**ASHLAND PLANNING DEPARTMENT**  
**PRE-APPLICATION CONFERENCE**  
**COMMENT SHEET**  
August 21, 2024

**SITE:** Granite Street TL 1800  
**APPLICANT:** Carlo Delgado/Tom Sager  
**OWNER:** Stephane and Bryan Deboer  
**REQUEST:** Physical & Environmental  
Constraints Review Permit for Hillside  
Development and Exceptions

Figure 1: Physical and Environmental Overlay Map of Granite Street Tax Lot 1800. See legend for slope/color reference.

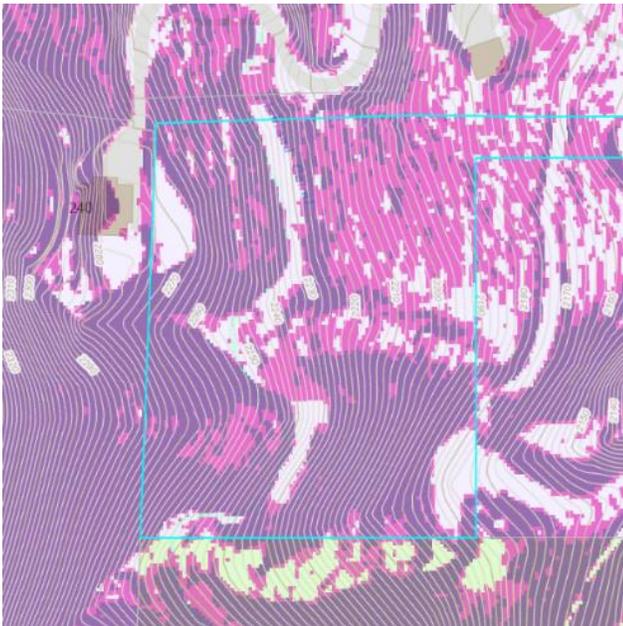
**Summary:** The proposal is for a new 4,798 square foot, single family residence on currently undeveloped steeply sloped land. The property is accessed from Granite Street and referenced as Tax Lot 1800. Portions of the lot are classified as “severely constrained” slopes. Severely constrained slopes are defined as slopes greater than 35 percent. On the image below generated by City GIS, the dark magenta areas are slopes greater than 35 percent, and the light magenta areas show slopes greater than 25 percent. The land use ordinance requires all new construction to occur on slopes less than 35 percent. However, AMC 18.3.10.090.A.1.a allows for “*Existing parcels without adequate buildable area less than or equal to 35 percent shall be considered buildable for one unit.*” The application states that the majority of development will occur on slopes with an average of 27 percent. The lot is within the Hillside Lands overlay and was created prior to the Hillside Lands ordinance. A Physical and Environmental Constraints Review Permit is required due to the steepness of the property and the presence of slopes greater than 35 percent.
